MINERALS PROGRAM INSPECTION REPORT
PHONE: (303) 866-3567

MINE NAME: Seeley Reservoir Stockpiles	MINE/PROSPECTING ID#: M-2023-043	MINERAL: Borrow material for construction	COUNTY: Weld
INSPECTION TYPE: Preoperation Inspection	WEATHER: Windy	INSP. DATE: January 9, 2025	INSP. TIME: 09:30
OPERATOR: Four C Sons, Inc.	OPERATOR REPRESENTATIVE: Scott Cockroft, Tim Naylor, Travis Koch	TYPE OF OPERATION: 112c - Construction Regular Operation	
REASON FOR INSPECTION: Pre-operation Inspection	BOND CALCULATION TYPE: None	BOND AMOUNT: \$0.00	
DATE OF COMPLAINT: NA	POST INSP. CONTACTS: None	JOINT INSP. AGENCY: None	
INSPECTOR(S): Amber Gibson Jared Ebert	INSPECTOR'S SIGNATURE: 	SIGNATURE DATE: January 17, 2025

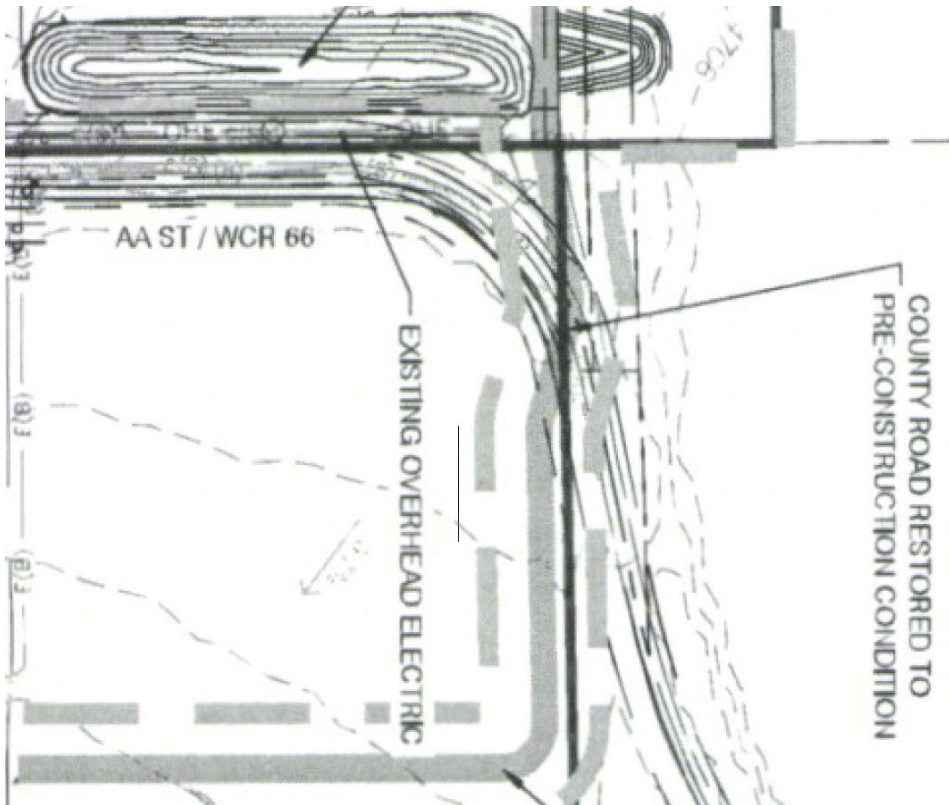
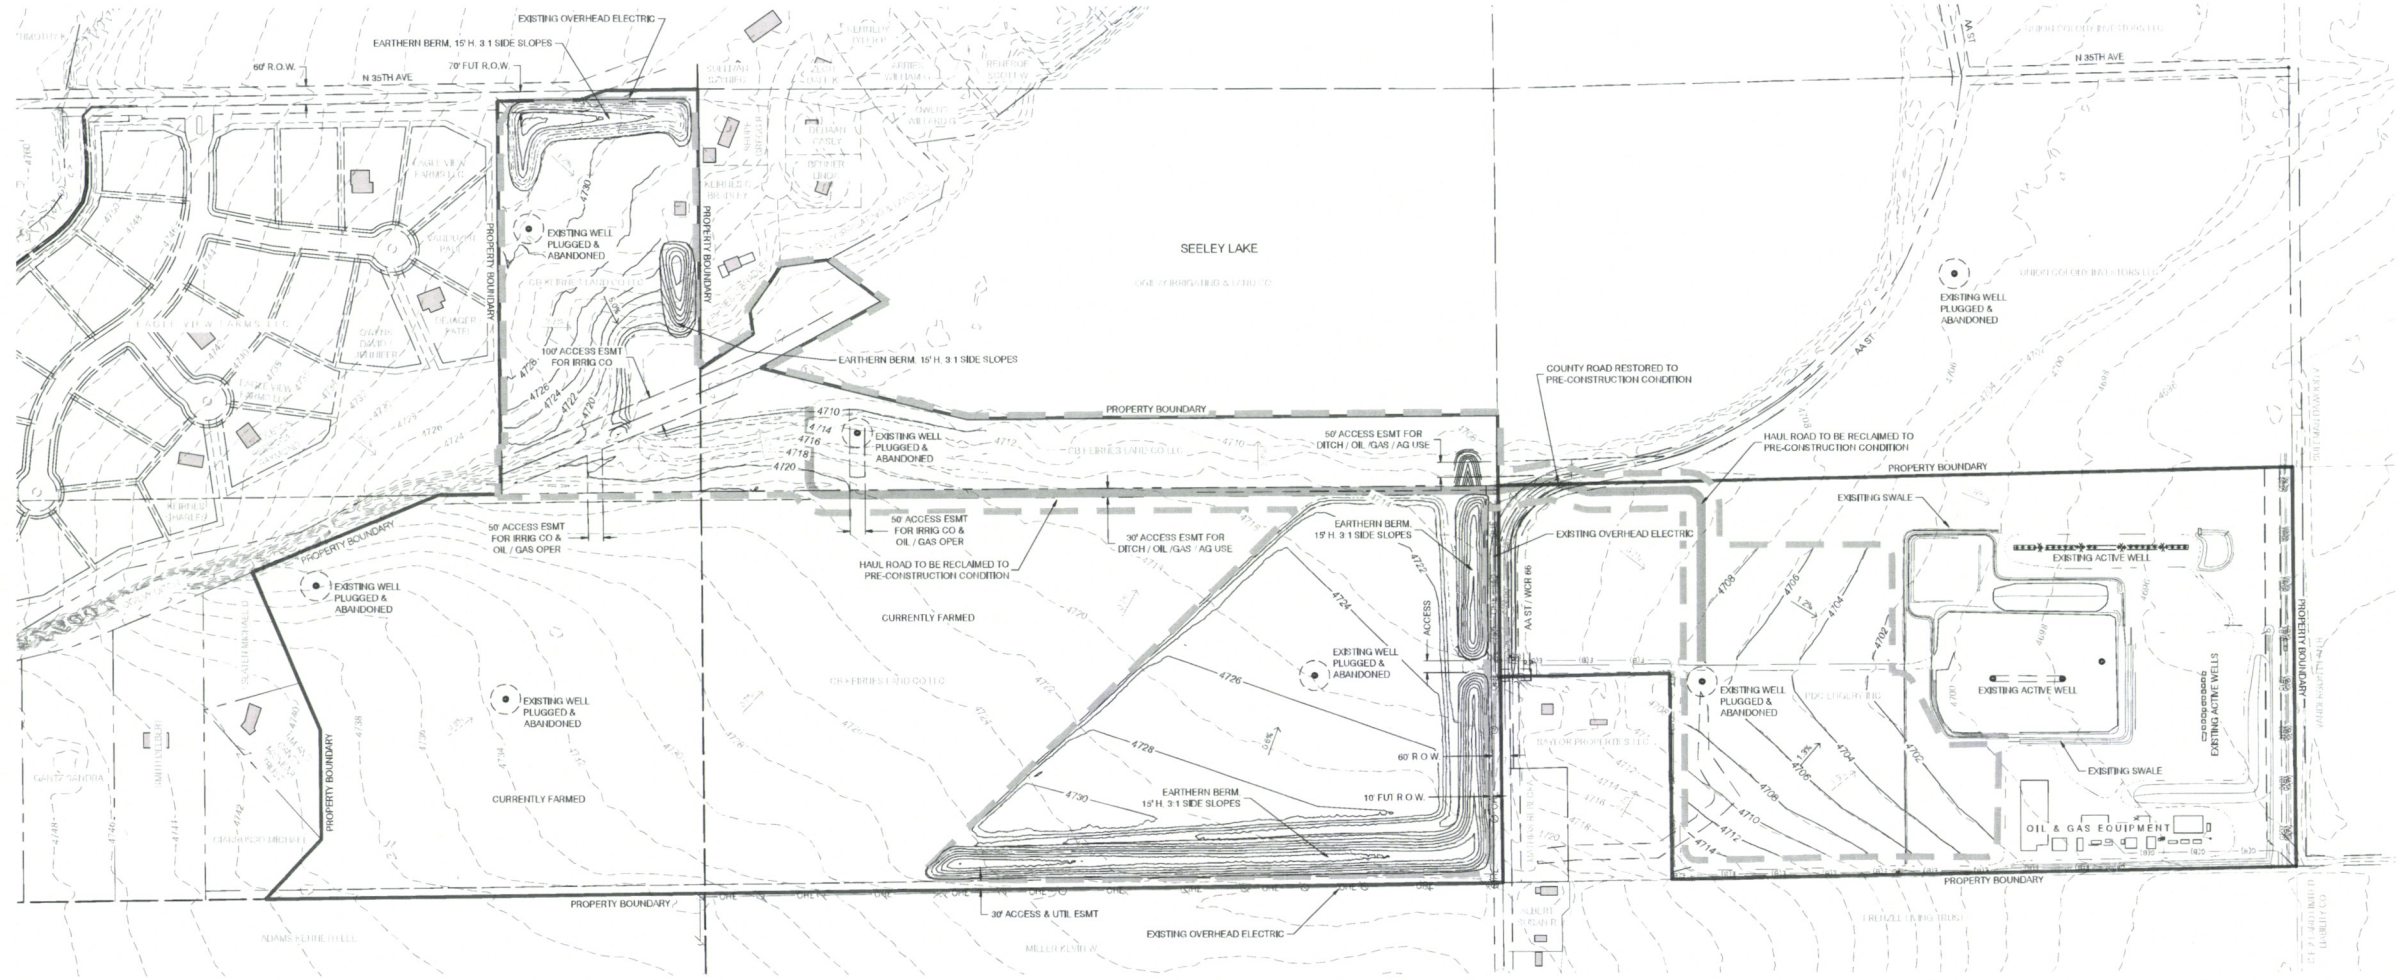
During the inspection, the landowners brought the inspectors and the Applicant to the location where they believed remaining materials needed to be reclaimed and included in the affected area of the permit boundary (Map 1; Figure 1; Photo 13). At the time of the inspection, the Applicant's stated that that material was on Ogilvy's property and was not included as part of the operation. However, following the inspection the Division discovered that this area is already included in the Applicant's affected area boundary (Figure 1). The reclamation of this portion of the permit will need to be further addressed and accounted for in the Applicant's adequacy responses.

Figure 1: (Right) Excerpt from the Applicant's Reclamation Plan Map Option 2. The dashed lines indicate the Applicant's affected area boundary. (Left) Approximate location of the Applicant's affected area boundary (yellow dashed line), haul road (red line), property/parcel boundary included on the maps (purple line), overlain on aerial imagery that pre-dates the dredging operation in ArcOnline. The red dot indicates the location where inspection Photo #13 was taken. In comparison with the Applicant's maps, the location where excess material was stored on Ogilvy's land during the dredging project is included in the affected area boundary. The reclamation plan for this area will need to be addressed via the Applicant's response to the Division's adequacy review of the permit application.
